ADDENDUM NO. 1

December 15, 2025

**COMSTOCK HALL 5TH FLOOR
LAB AND SUPPORT SPACE
RENOVATIONS**
129 Garden Ave
Ithaca, NY 14853
SWBR Project Number 25044.00

Cornell University
Ithaca, NY 14853

AD-101R
FIFTH FLOOR
DEMOLITION PLAN

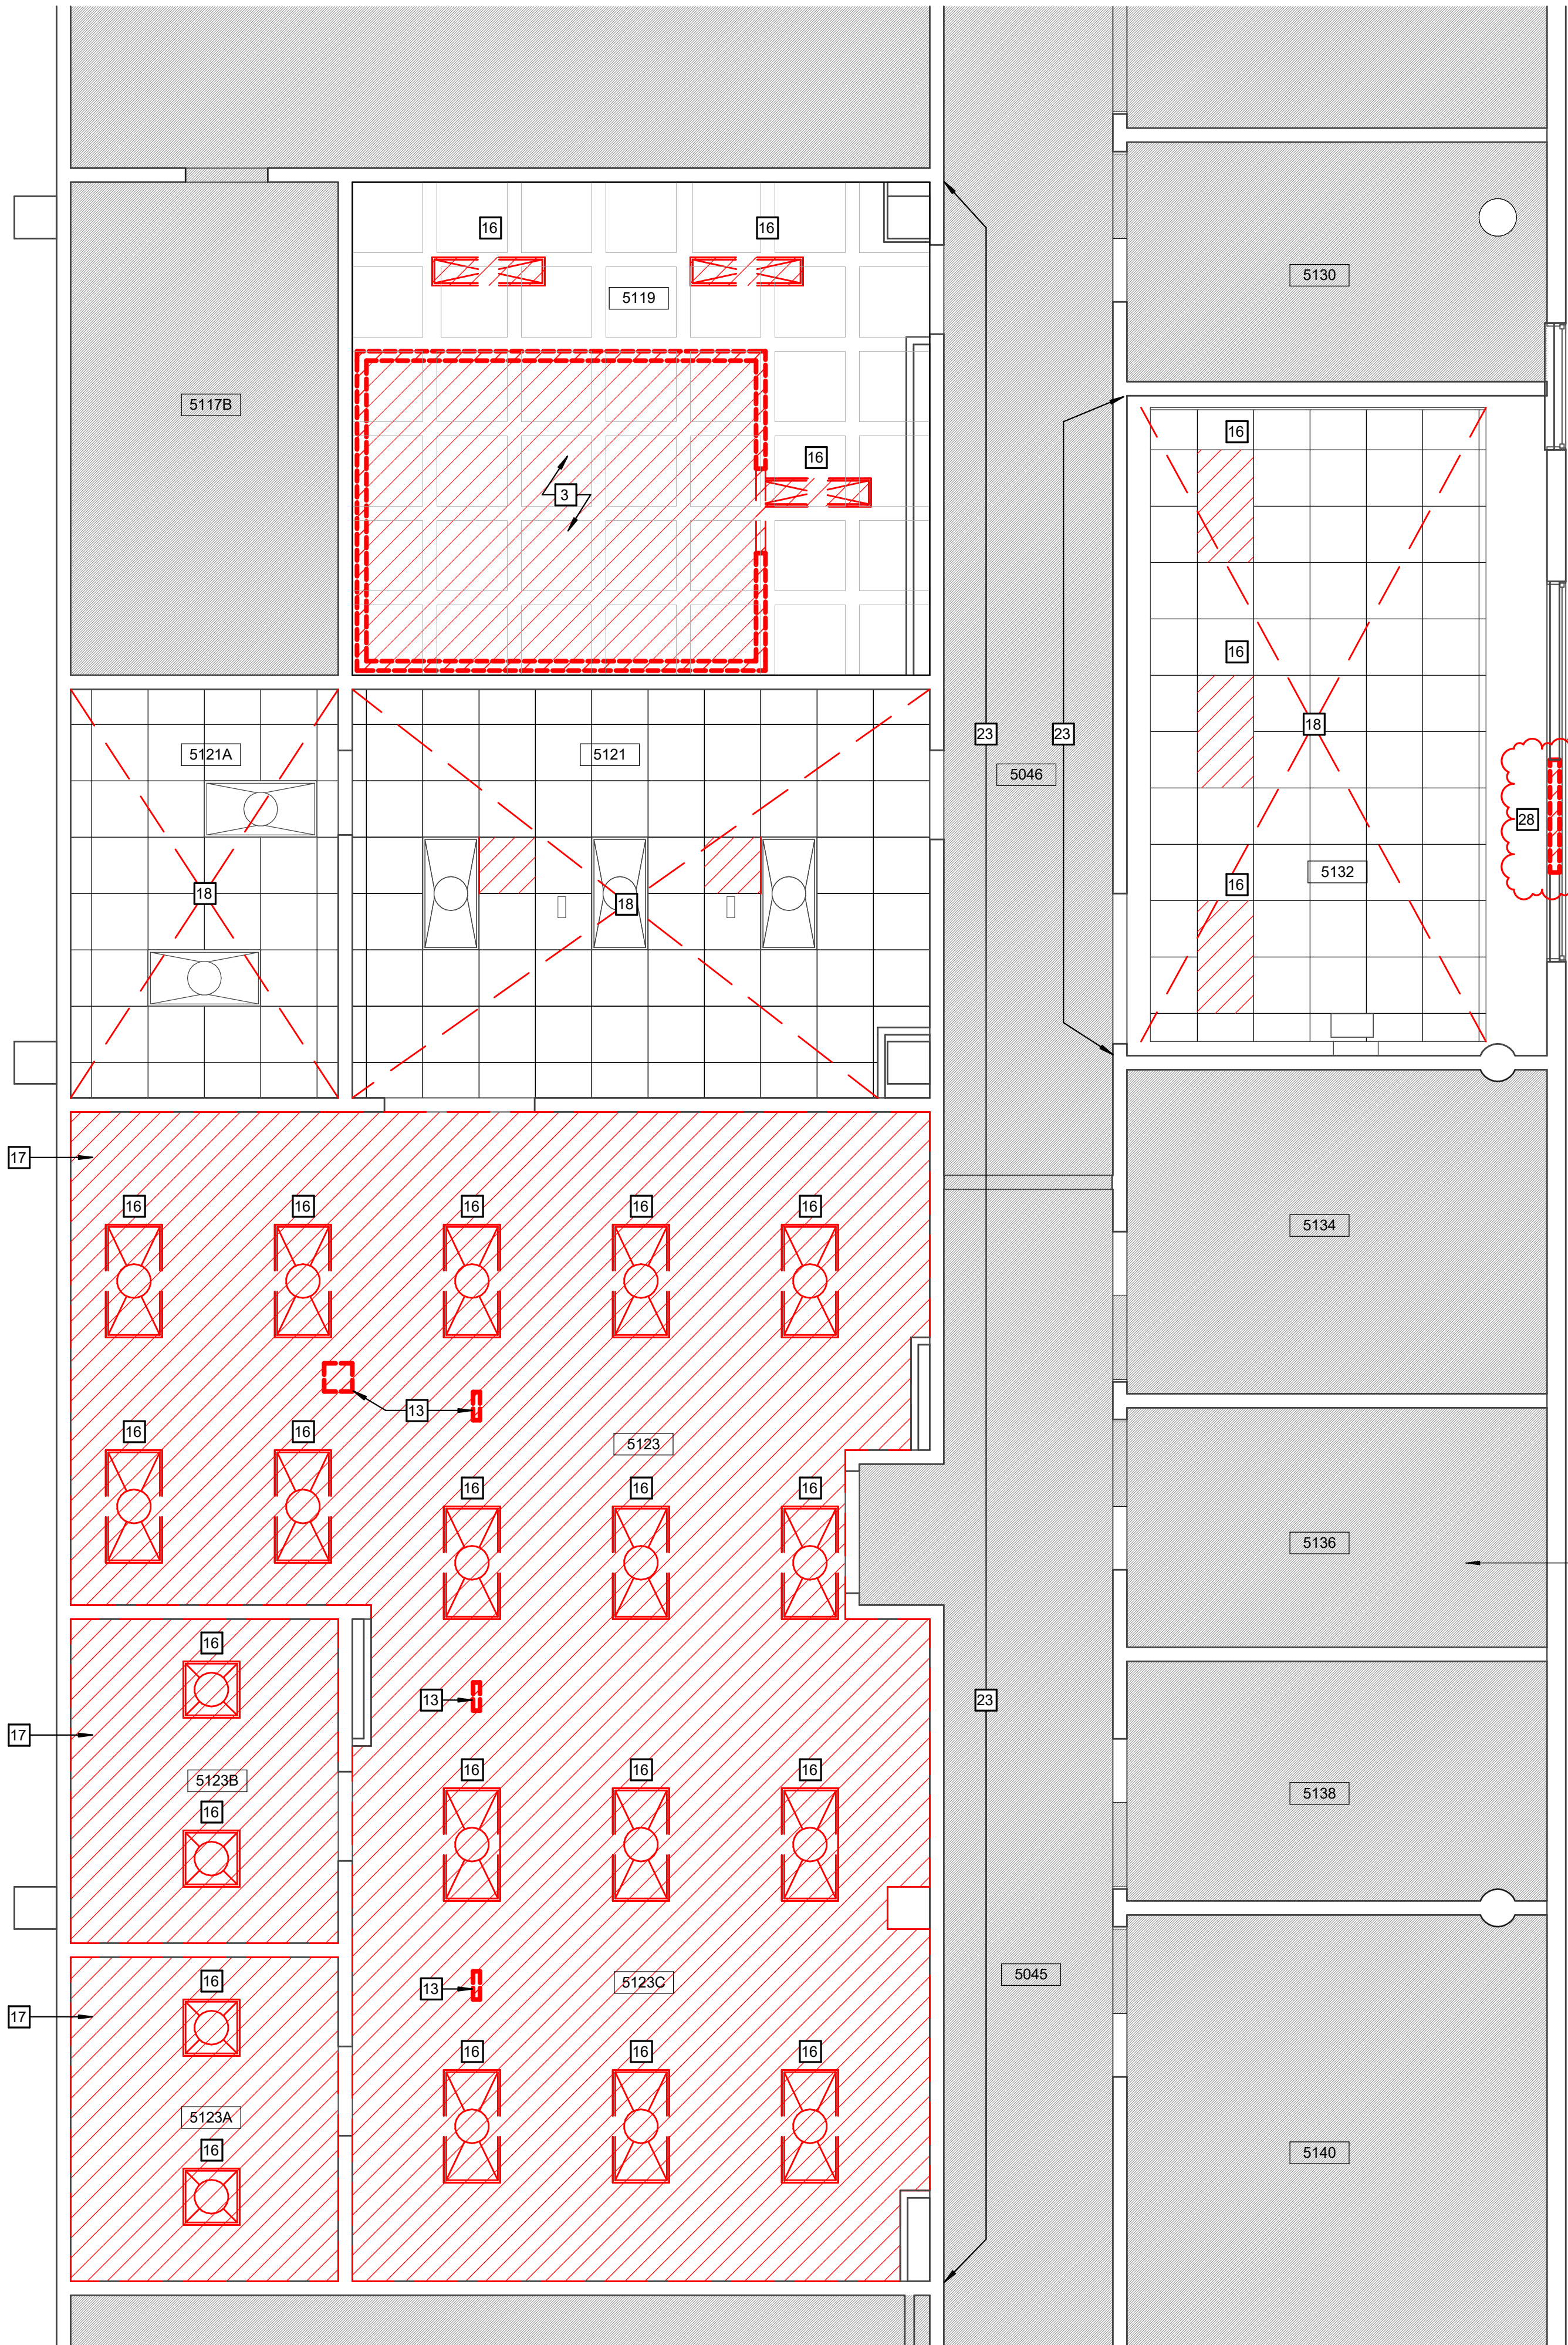
Item 5. DRAWING AD-101 – Fifth Floor Demolition Plan

DELETE in its entirety,

REPLACE with revised Drawing AD-101R, attached.

1 PARTIAL FIFTH FLOOR CEILING DEMOLITION PLAN
1/4" = 1'-0"

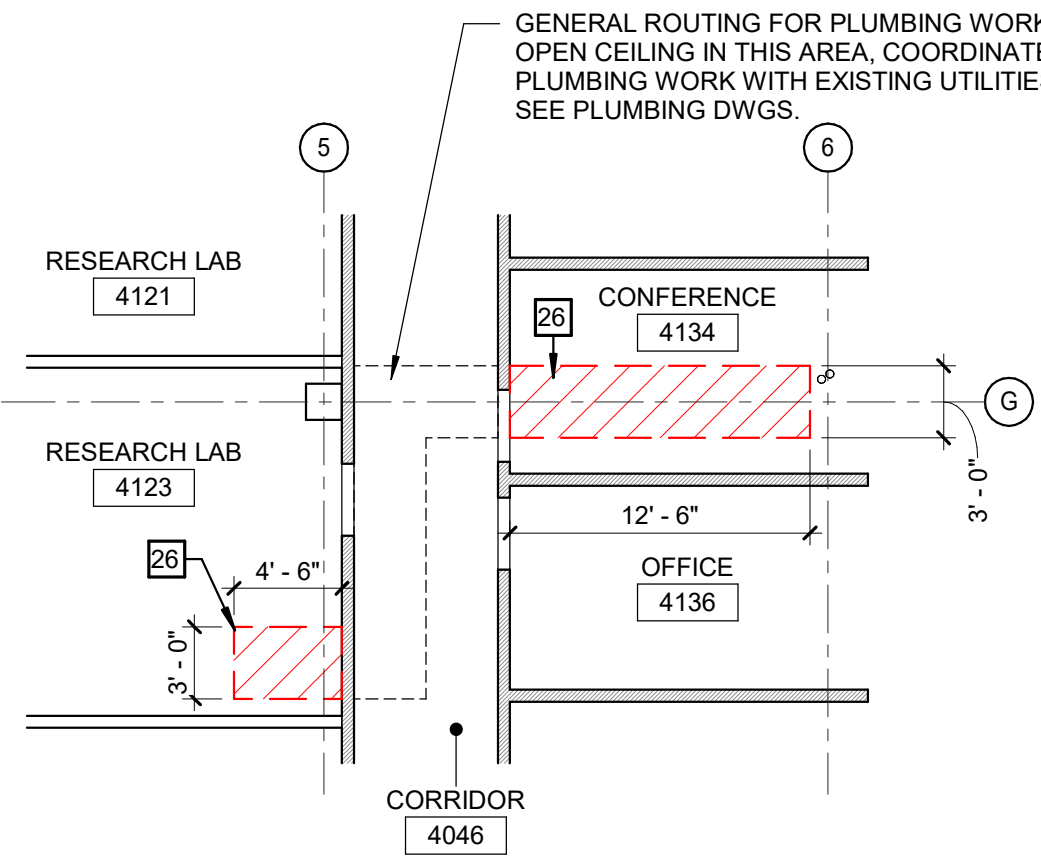
Item 6. DRAWING AD-111 – Fifth Floor Demolition RCP

DELETE in its entirety,

REPLACE with revised Drawing AD-111R, attached.

A-421R

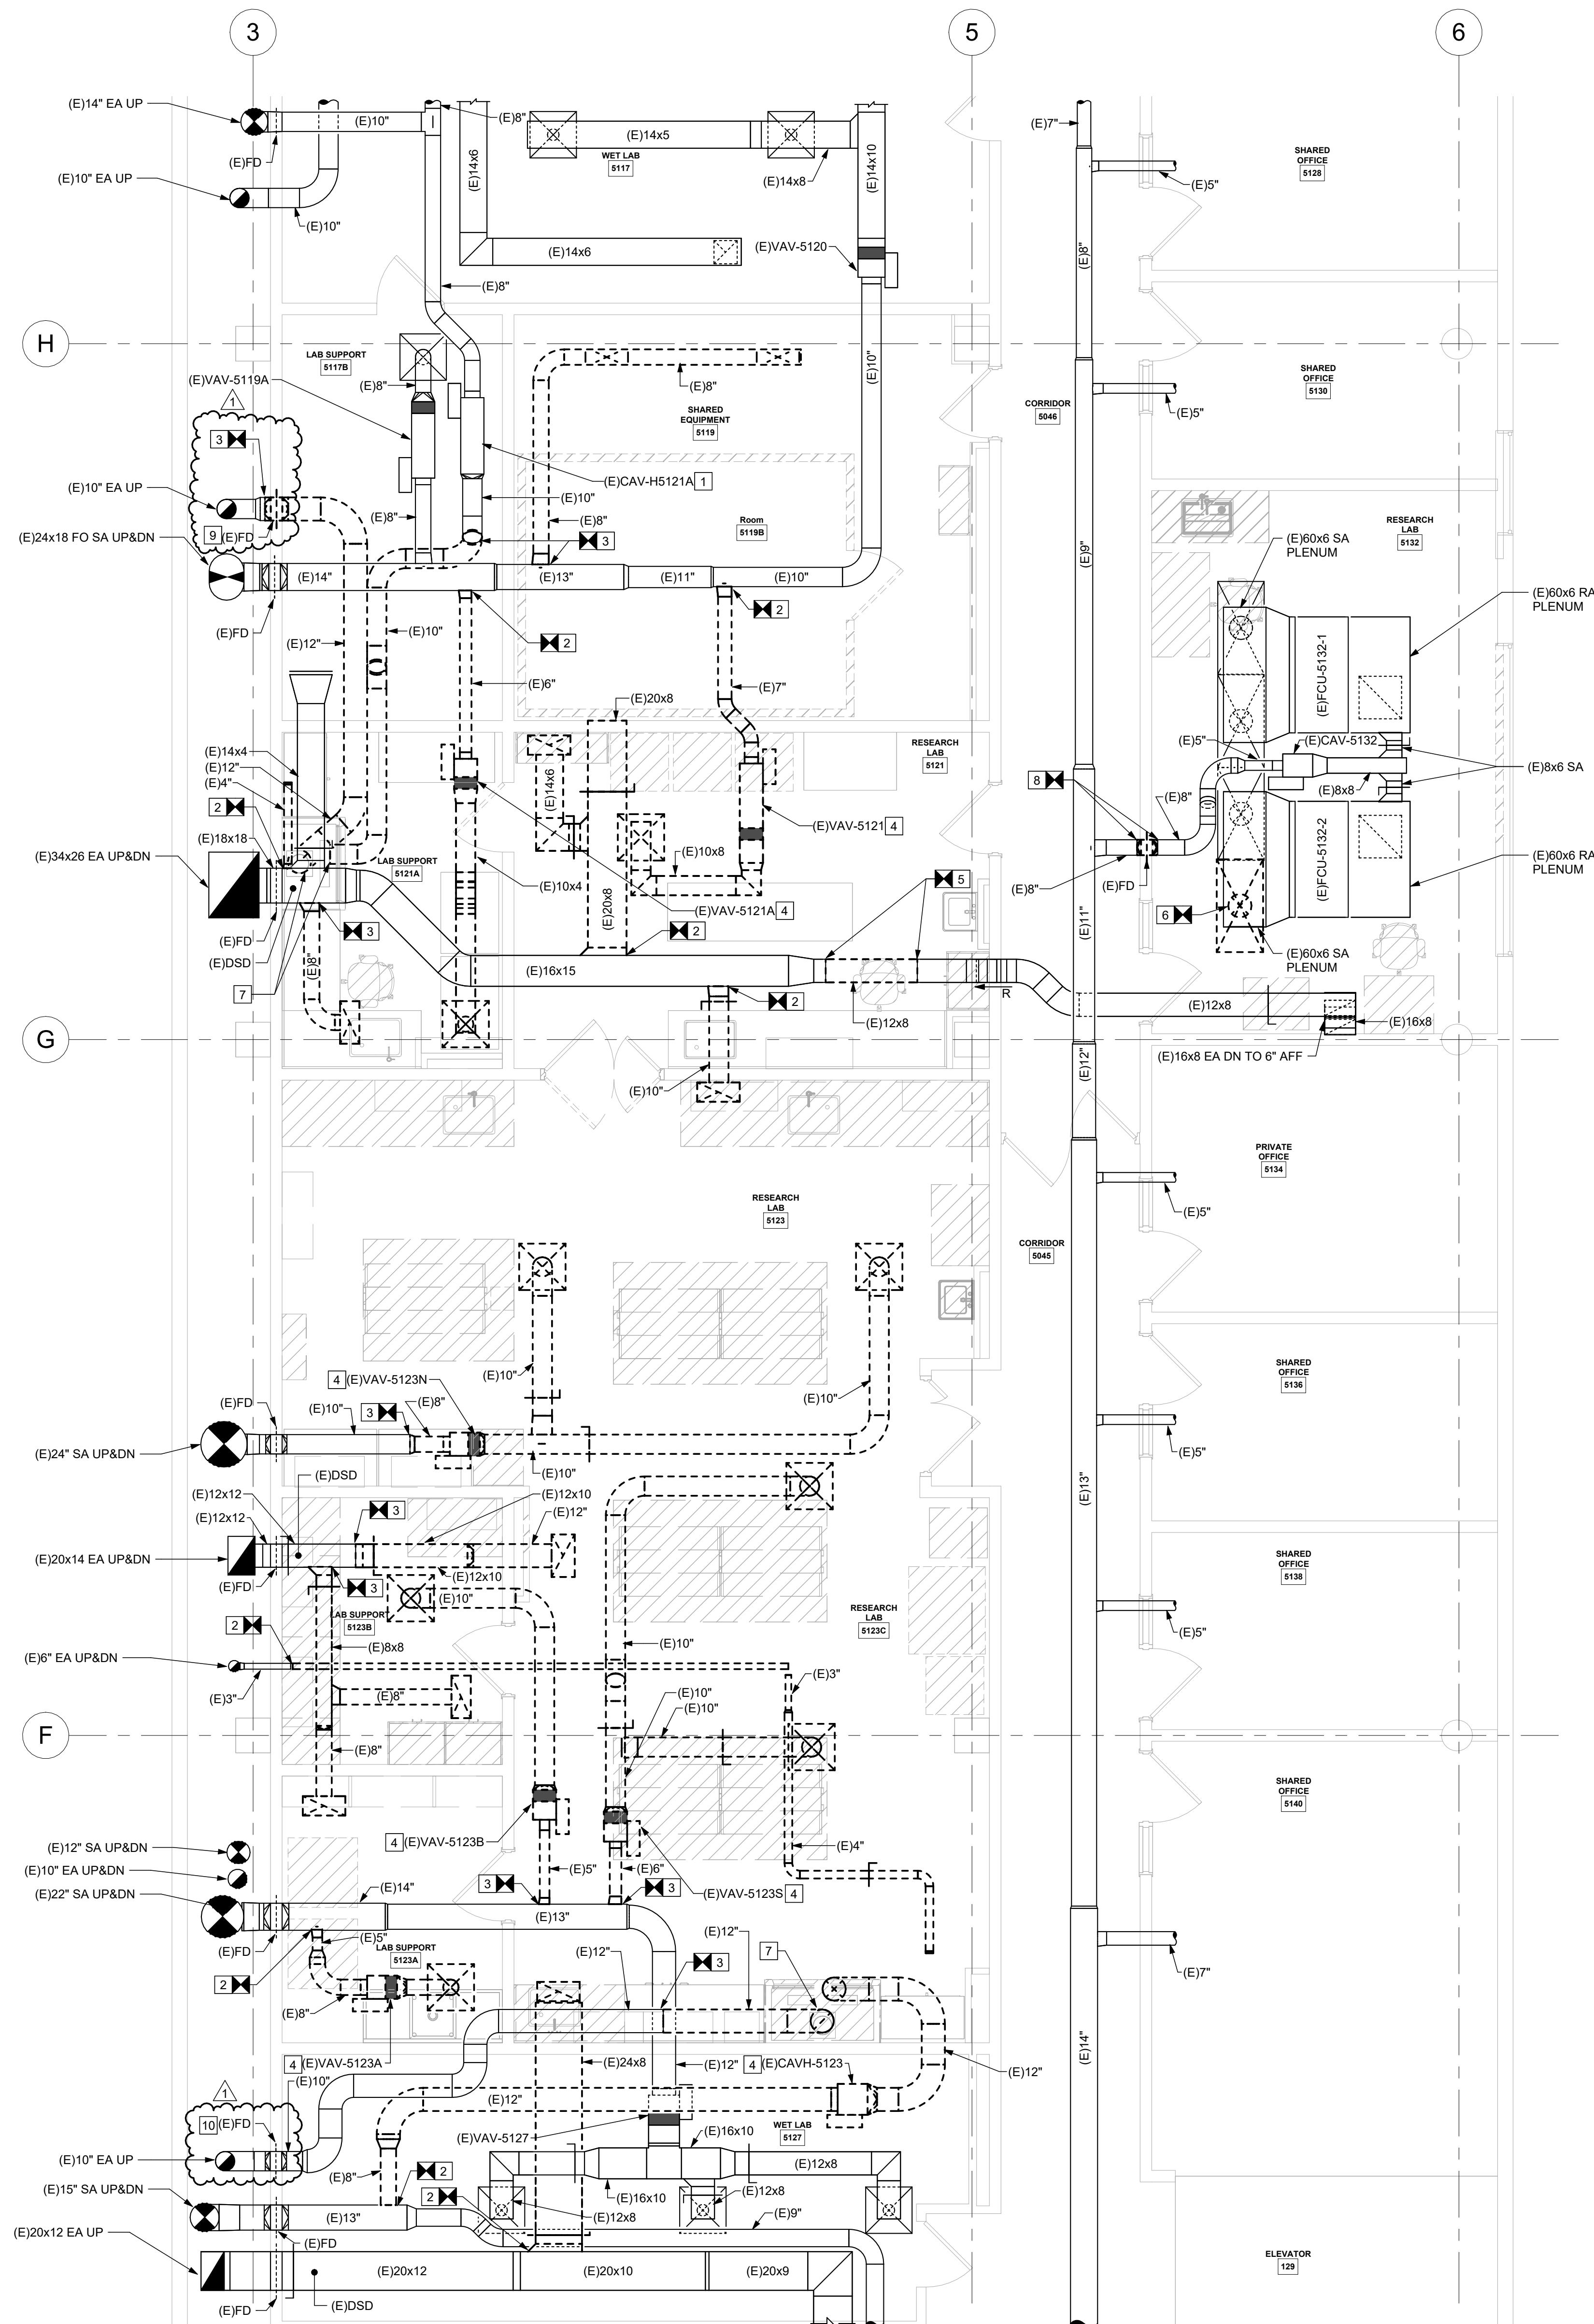
Item 9. DRAWING A-421 – Interior Elevations

DELETE in its entirety,

REPLACE with revised Drawing A-421R, attached.
